RT-138F NARROW BAND CONVERSION MAINTENANCE MANUAL ADDENDUM

Section 2 Theory of Operation

Figure 2-1. RT-138F Narrow-Band Audio Board Block Diagram

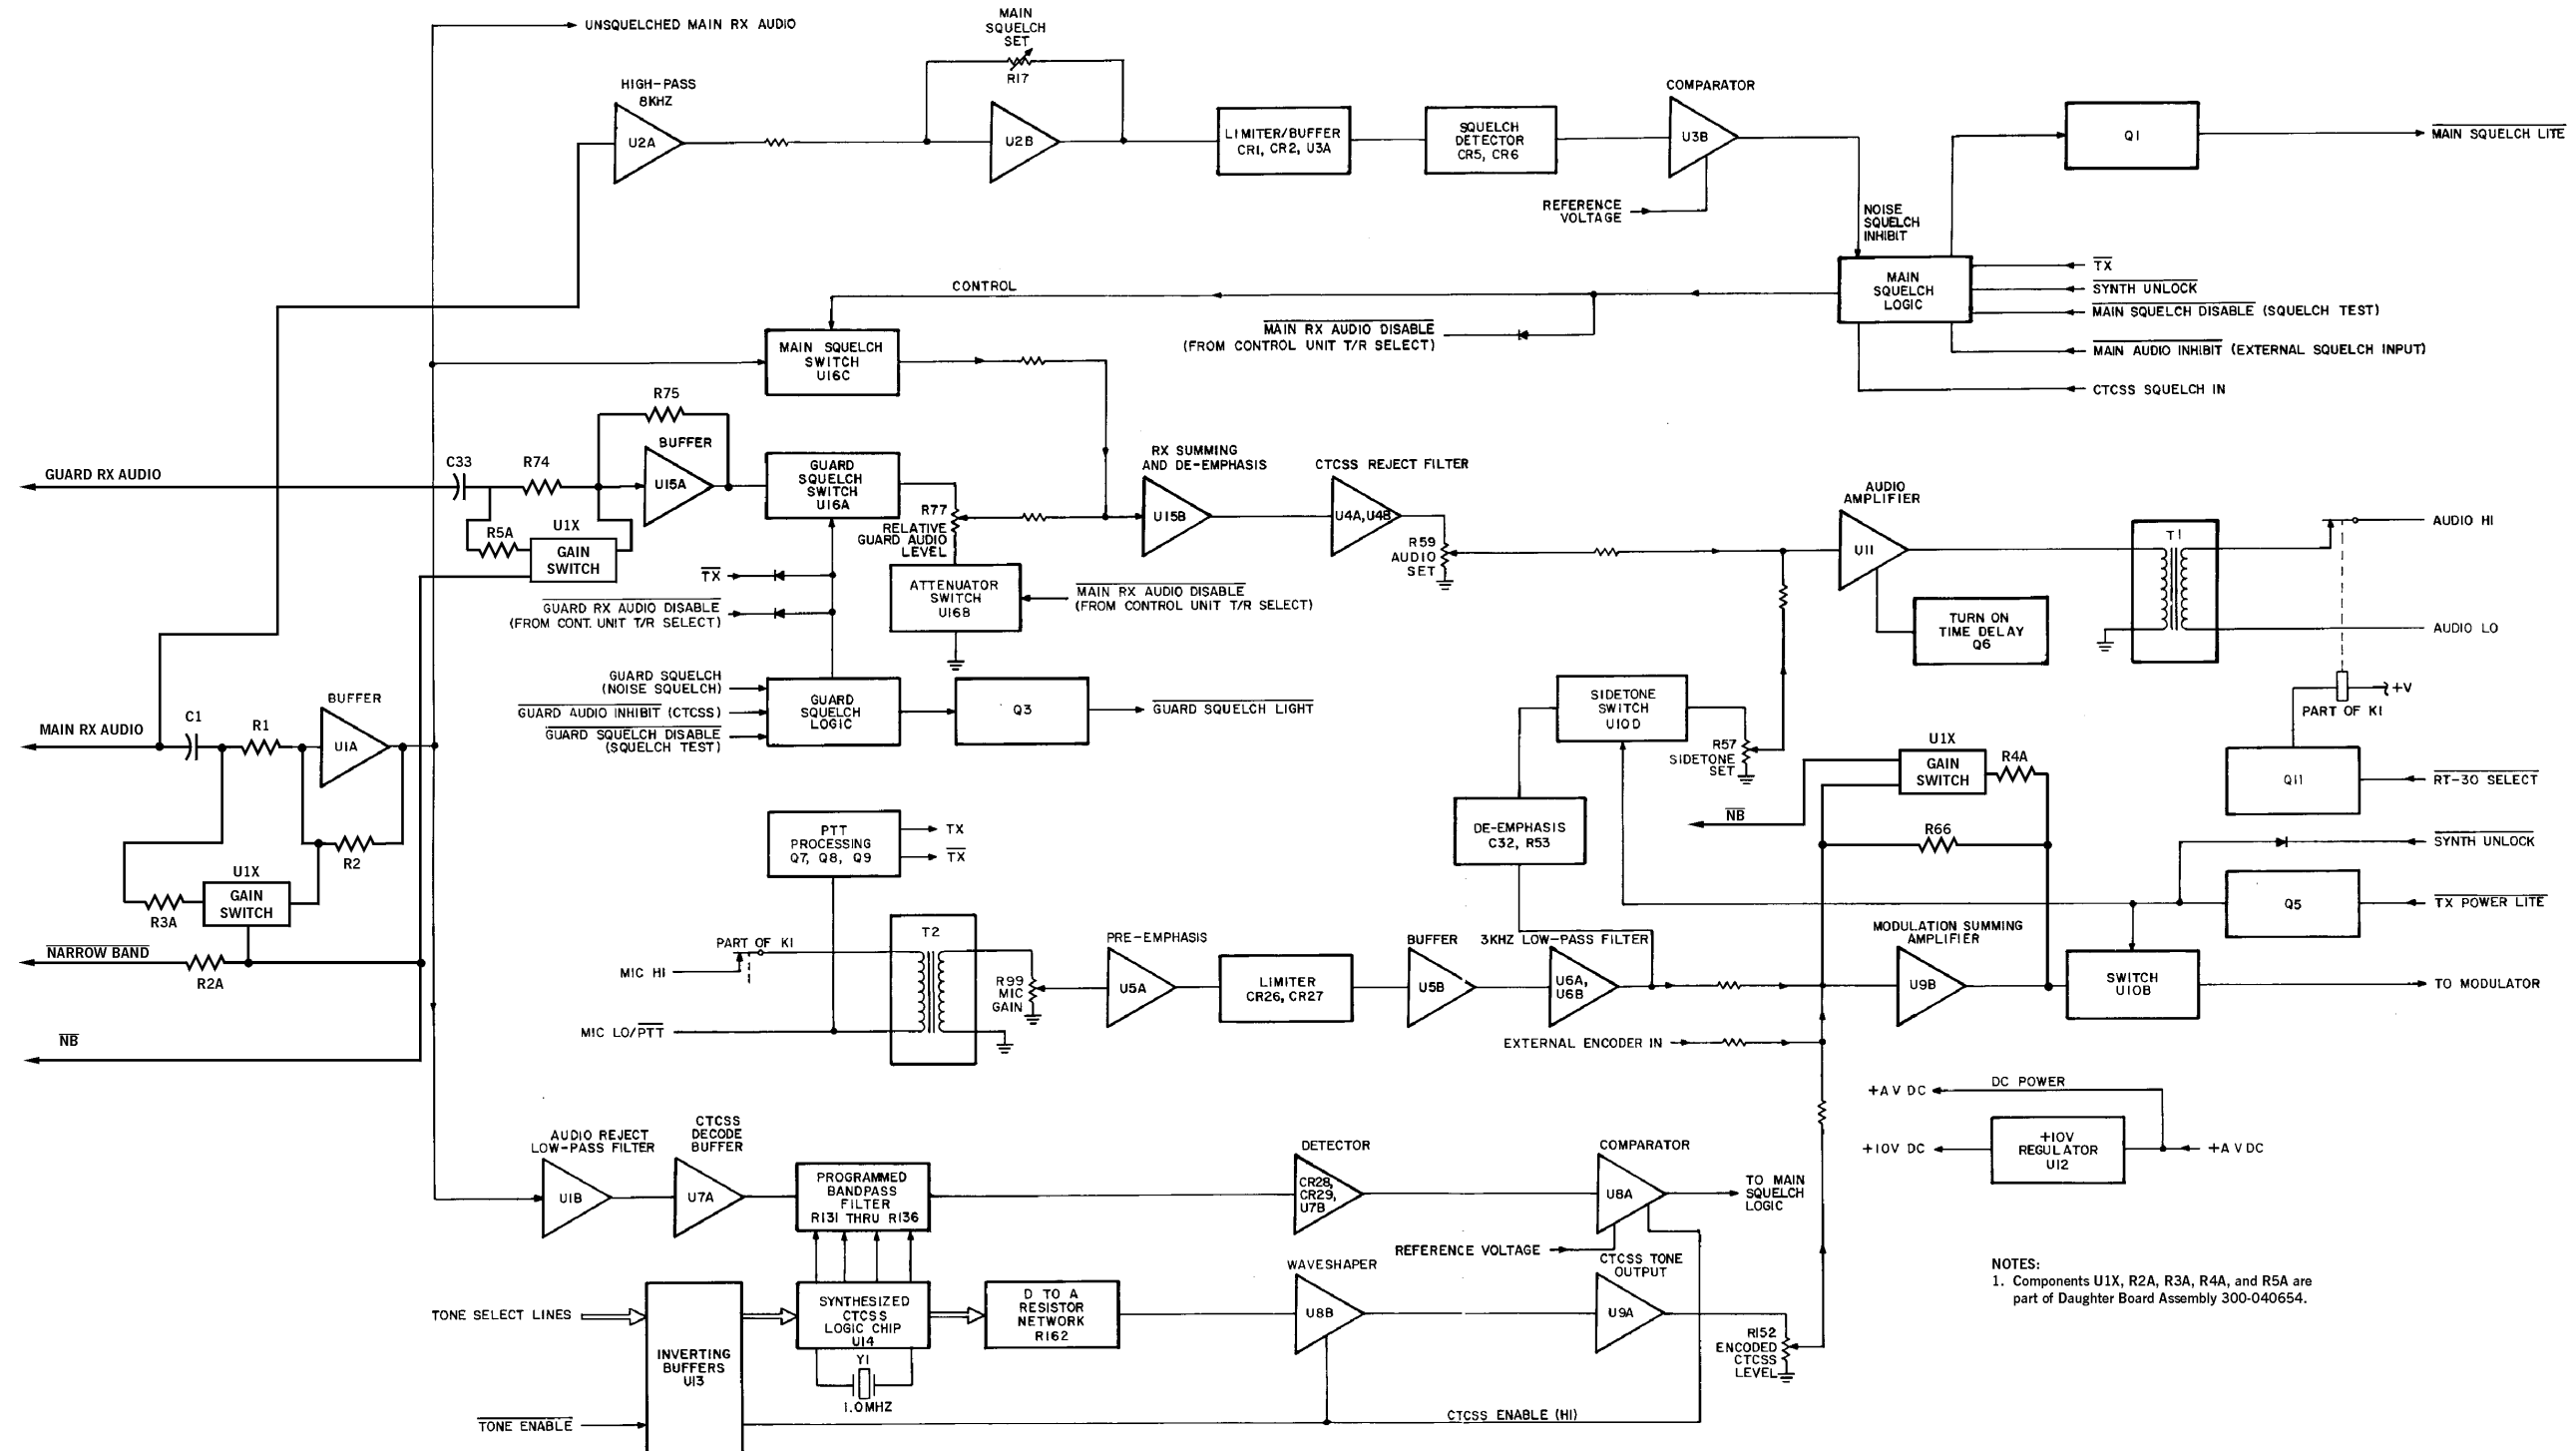
Figure 2-1 is a block diagram illustrating the operation of the '-050' Audio board used in the RT-138F with the narrow band Daughter board installed.

A3U1A, the Main Receiver inverting buffer no longer drives the main squelch circuitry in the narrow banded Audio board. The signal for the main squelch circuitry is now taken directly from pin A3P3-21 and input to the isolated leg of C4. The reason for this change is because the gain of A3U1A is now switchable to double the amplitude of the incoming audio when in the narrow band mode. Since the gain is doubled in the narrow band mode, the noise is also doubled. The squelch circuitry therefore would sense the extra noise and squelch accordingly. This would create one squelch point for narrow and a different point for wide band depending on which is selected on the C-1000 control head. By picking off the signal before it gets to A3U1A, the squelch remains consistent regardless of the gain selected for the buffer and independent of whether the incoming signal is narrow or wide band.

The Guard Audio Buffers' gain is also switchable for the purpose of doubling the amplitude of an incoming narrow band signal. The squelch circuitry however, is contained in the Guard so the signal received by the Audio board from the Guard has already been screened for squelch.

A3U9B, the Modulation Summing Buffer, also has switchable gain. It's gain however, is cut in half by the gain switch in the narrow band mode in order to keep the modulation within narrow band specs during transmit.
